**RE: RESPONSE TO ECOLOGY COMMENTS ON TECHNICAL MEMORANDUM,
SUPPLEMENTAL SUBSURFACE INVESTIGATION AND FOUNDATION
ELEMENTS
BLOCK 38 WEST SITE
500 THROUGH 536 WESTLAKE AVENUE NORTH
SEATTLE, WASHINGTON
FARALLON PN: 397-019**

Attachment A**Block 38 West Site, Seattle, WA****Agency Review Comments****Document:** Technical Memorandum: *Supplemental Subsurface Investigation and Foundation Elements* (Farallon, June 15, 2020)**Comment Date:** August 12, 2020**Response Comments Date:** September 2, 2020

FIGURE 1
PROPOSED BORING LOCATIONS
BLOCK 38 WEST SITE
SEATTLE, WASHINGTON

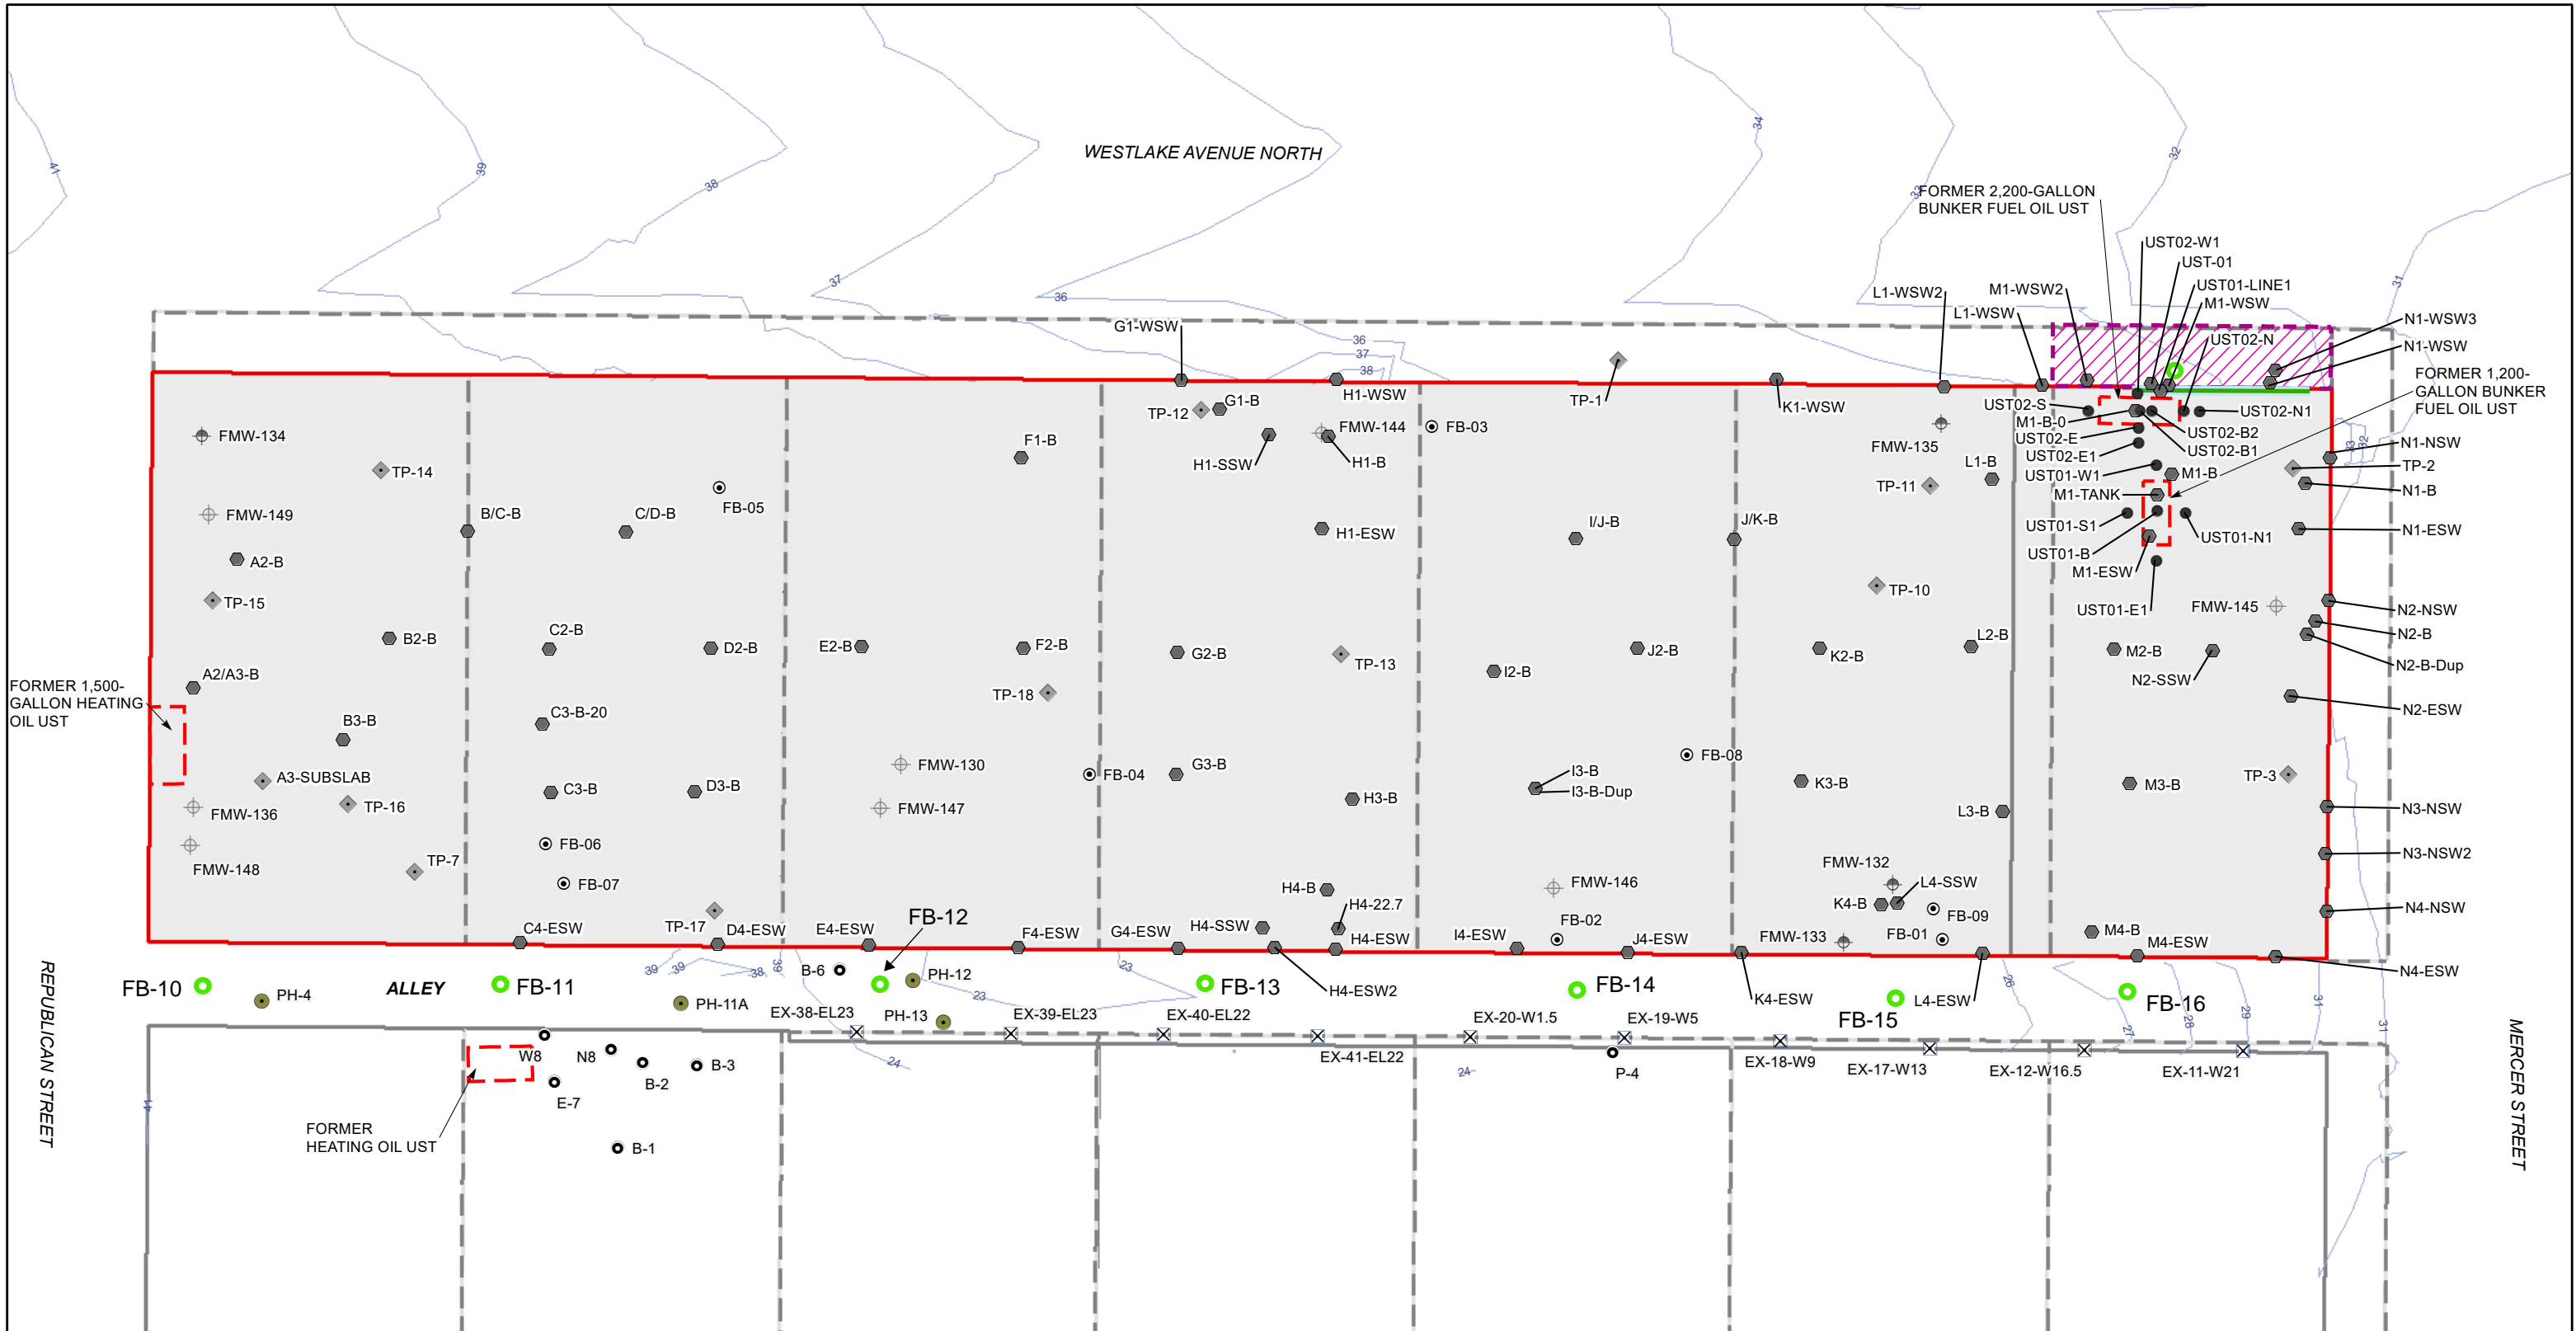
Supplemental Subsurface Investigation, 4 th paragraph	6	The use of "potential" regarding lab analysis of the soil samples to be collected is vague and implies that some may not be analyzed for certain compounds. All of the samples from each of the proposed elevations and from a shallower elevation (~22-23 ft) should be analyzed for all of the analytes listed here. If there are any that would potentially not be analyzed, please provide explanation and justification for that.	Please see Attachment C, Revised Figure 1 and Table 1 from the Sampling and Analysis Plan. Each proposed boring has been numbered, sample collection intervals refined and the proposed analytes for each boring provided for review.
Supplemental Subsurface Investigation, 5 th paragraph	6	Please explain what are the steps if the limits of the contamination cannot be defined (mostly vertically) with this work. Would there be additional actions?	The vertical extent of COCs (ORO and cPAHs) impacts in soil at the eastern sidewall of the Block 38 West Property was defined at elevation 15 feet NAVD88. Although not anticipated based on the thickness of the soil fill layer observed on the Block 38 West Property if COCs are detected in soil at concentrations exceeding the screening levels at the maximum depth explored then additional investigation will be required to define the extent of COC contamination in the alley. The monitoring wells proposed in the alley under the remedial investigation would provide an opportunity to collect deeper soil samples when they are installed.

Table 1		This table is too vague regarding scope and rationale. It should list the proposed locations and provide justification for each of the samples being analyzed and their proposed analyses; be more specific in the rationale for each sample location, depth, and corresponding analyses (e.g., “to delineate southern and vertical extent of cPAHs”, to delineate western extent of lead at the 22-ft elevation near previous sample location XX”).	Please see Attachment C, Revised Figure 1 and Table 1 from the Sampling and Analysis Plan. Each proposed boring has been numbered, sample collection intervals refined and the proposed analytes for each boring provided for review.

Section 3.1, 2 nd paragraph	3-1	Same comment as above – include samples from ~22-23 ft elevation	Please see Attachment C, Revised Figure 1 and Table 1 from the Sampling and Analysis Plan. Each proposed boring has been numbered, sample collection intervals refined and the proposed analytes for each boring provided for review.
Section 3.1, 3 rd paragraph	3-1	Samples for volatile analysis should be sampled in accordance with EPA Method 5035A. It is not clear in this document (nor in the	A sentence was added to the 3 rd paragraph stating that soil for volatile analysis will be collected in accordance with EPA Method
